**Historic Review**  
**Staff Report for a Single Family Home in the Canemah Historic District**  
**August 17, 2018**

**FILE NO.:** HR 18-11: Historic Review Board review of a new single family home and detached garage with upper floor accessory dwelling unit in the Canemah National Register Historic District.

**REQUEST:** New single family home and detached garage with upper floor accessory dwelling unit in the Canemah National Register Historic District. Application includes a request for preservation incentive to reduce side setback.

Site Plan

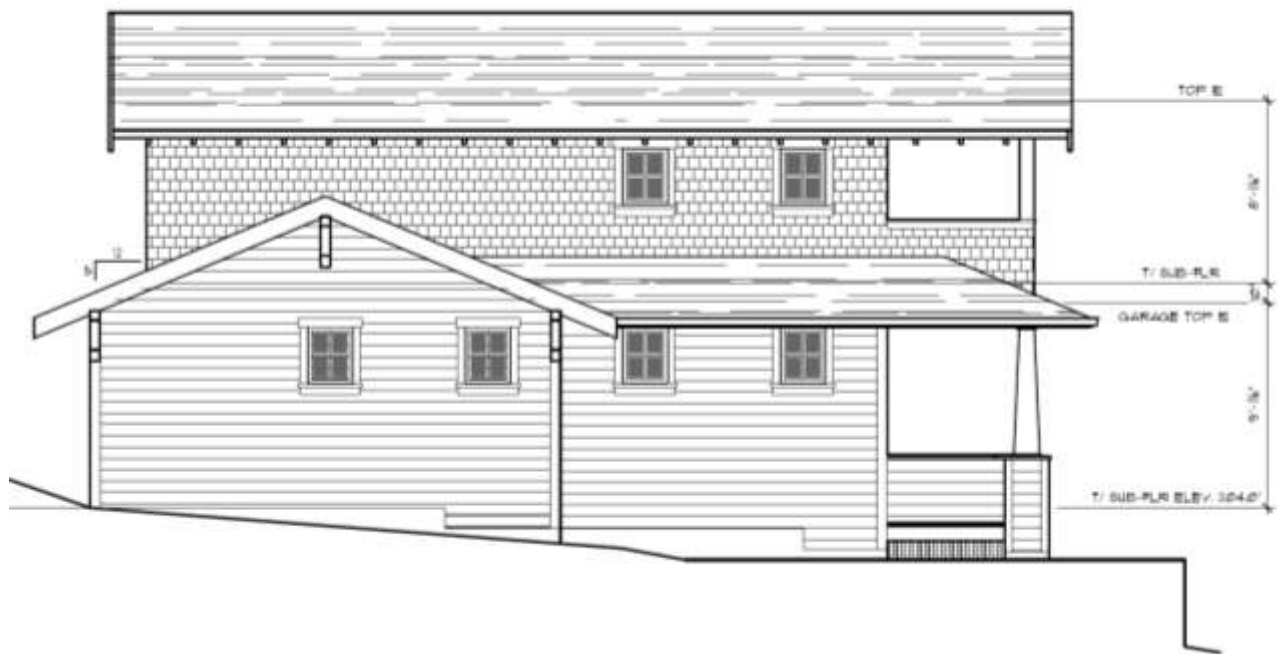
The house is proposed to face 4<sup>th</sup> Avenue. Rockery retaining walls are proposed on site. A 5 foot high retaining wall is proposed along the back side of the home and driveway area. Natural rockery walls that are less than 4 feet are allowed on the site without further Historic Review Board review. The proposed retaining wall shall be a rockery wall, or utilize concrete or natural basalt veneer. Any other material or a height change of more than one foot shall be considered a modification to this application and be reviewed by the Historic Review Board.

**Finding: Complies as Proposed:** A preservation incentive has been proposed as part of this application, to reduce the side setback from 9 feet to 5 feet for the detached garage/ADU. The side property line borders the 10' unimproved alley and is not directly adjacent to other private property. Staff finds that the preservation incentive is acceptable for the following reasons:

6. Natural rockery walls that are less than 4 feet are allowed in the site without further Historic Review Board review. The proposed retaining wall shall be a rockery wall, or utilize concrete or natural basalt veneer. Any other material or a height change of more than one foot shall be considered a modification to this application and be reviewed by the Historic Review Board. (P)

East elevation

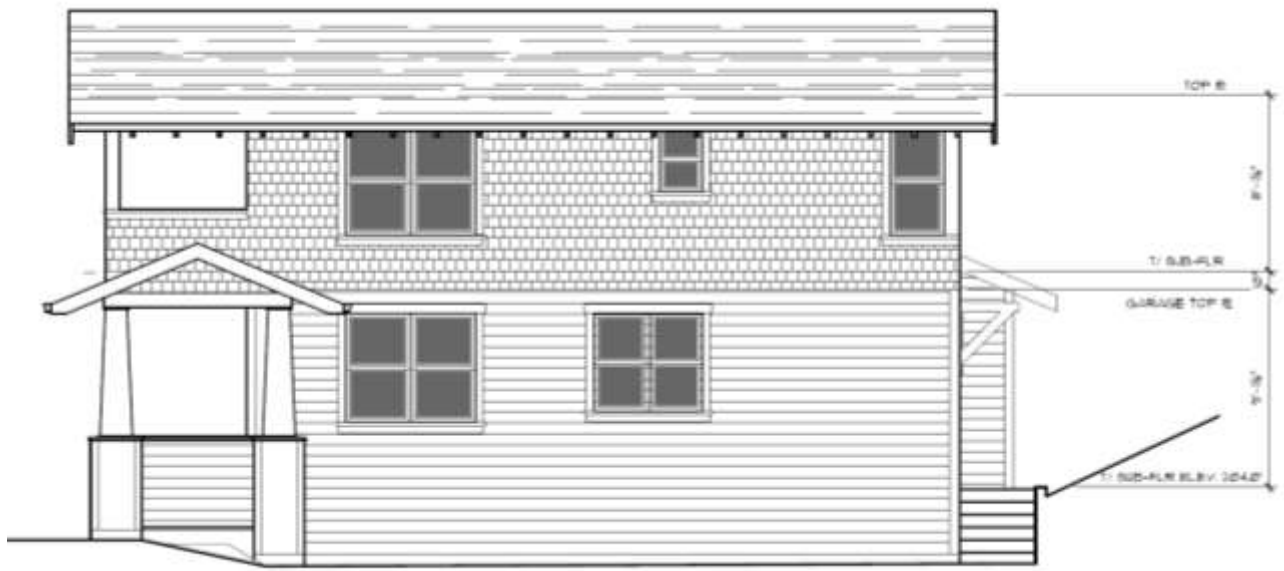
The applicant has proposed a home with detached ADU/garage with a “modified bungalow” design. The proposed home is two stories with a front porch on both floors. While many of the design details meet the design standards, the two story home with second story porch does not follow the design guidelines

1. Second floor porch/deck: Front porches on bungalows in Canemah are limited to the first floor. Second story porches are not supported by the design guidelines, and the applicant has not made an argument as to why the design deviates from the guidelines. The front gable porch is flush with the first story porch, creating verticality that is neither found in Canemah or any northwest bungalow design.

2. Two story design: Design guidelines call for 1 to 1.5 stories for bungalows in Canemah. The applicant has proposed a 7' second story and 24' overall height. This height, combined with the front gable second story porch, creates too much a vertical element and does not meet the design guidelines. On its own, the proposed height is marginally appropriate.
3. The front porch utilizes a hip roof on the left side and a gable end on the right side. While this may be acceptable, the Board may add a condition to use gable ends for both sides of the porch.
4. Window design: the front façade contains many window types in an asymmetrical design. While asymmetry is typical, combined with oversized windows it may be too busy for the typical bungalow design. Staff has not included a condition of approval, but the Board may want to consider adding one.

The applicant has also proposed a second story porch/deck, covered by an extension of the gable roof. Second story porches are not supported by the design guidelines. The front gable second story porch creates a more vertical element and is not found in Canemah or any bungalow style in the northwest. Staff recommends either denial of the application for this reason, continuing the hearing to allow the applicant to redesign the house with more appropriate second story design, or using a specific condition of approval:

Home: The front façade is asymmetrical due to window variation and left side wing, and the front porch is symmetrical. The front porch utilizes a hip roof on the left side and a gable end on the right side. While this may be acceptable, the Board may add a condition to use gable ends for both sides of the porch.

Windows on the front facade include a large fixed window on the first floor plus a 3 over 1 fixed, and 3 over 3 casement, and French doors with large fixed windows on the second story. While asymmetry is typical, combined with oversized windows, it may be too busy for the typical bungalow design.

3. The second story front porch shall be recessed behind the front façade into a side gable utilizing a shed dormer. Minor changes to window location on the side and rear facades will be acceptable and may be approved at a staff level prior to building permit issuance. (P)

The second story front porch shall be recessed behind the front façade into a side gable utilizing a shed dormer. Recessing the porch in this manner would substantially reduce the two story massing and make the design more horizontal, as well as being consistent with the bungalow style.
